Date Issued :	April 24, 2023	PCN Number :	513014
Reason for Change :	Change to Product		
Description of Change :	M12 COUPLING NUT MA/FE CHANGE TOLERANCE. Diameter tolerance change from 14.5 +0.5 to 14.5 +0.3/-0.1 mm. Depending on the supplier method used, the material throw-up is sometimes somewhat larger and sometimes only very minimal		
Reason for Short Notice :	Corrective Actions		
Assessment of Change :	Reliability Test Report/s		
Planned Implementation Date :	June 30, 2023		
Sample Availability Date:	May 19, 2023		
Internal Molex Qualification Date :	May 31, 2023		
Last date to request Samples by Customer :	June 05, 2023		
Traceability Code Markings / Date :	No special marking on the product or packaging

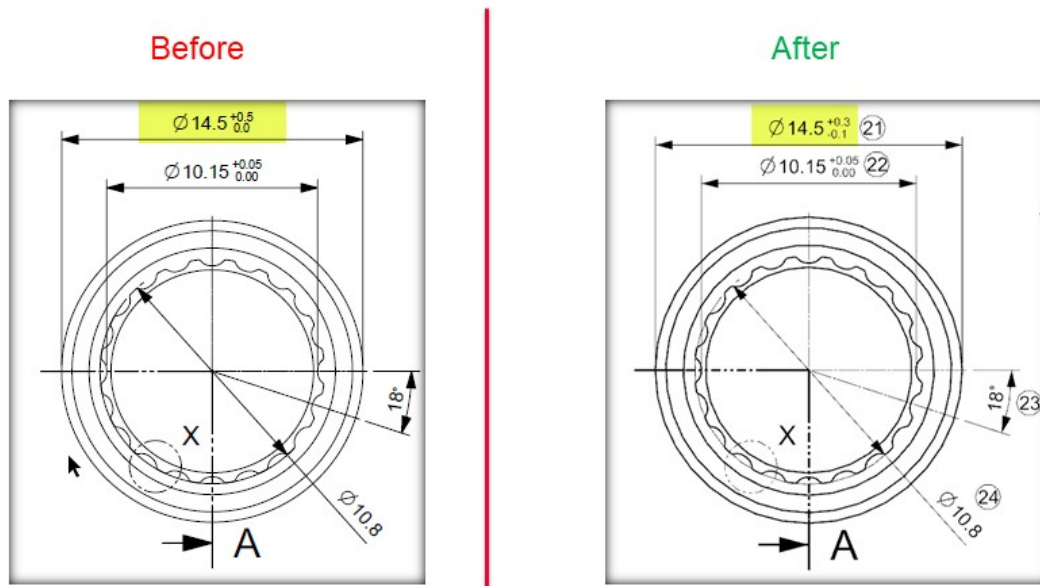
- Diameter tolerance change from 14,5+0,5/0 to 14,5+0,3/-0,1

- Product Impact
 - no impact to form, fit and function of the product
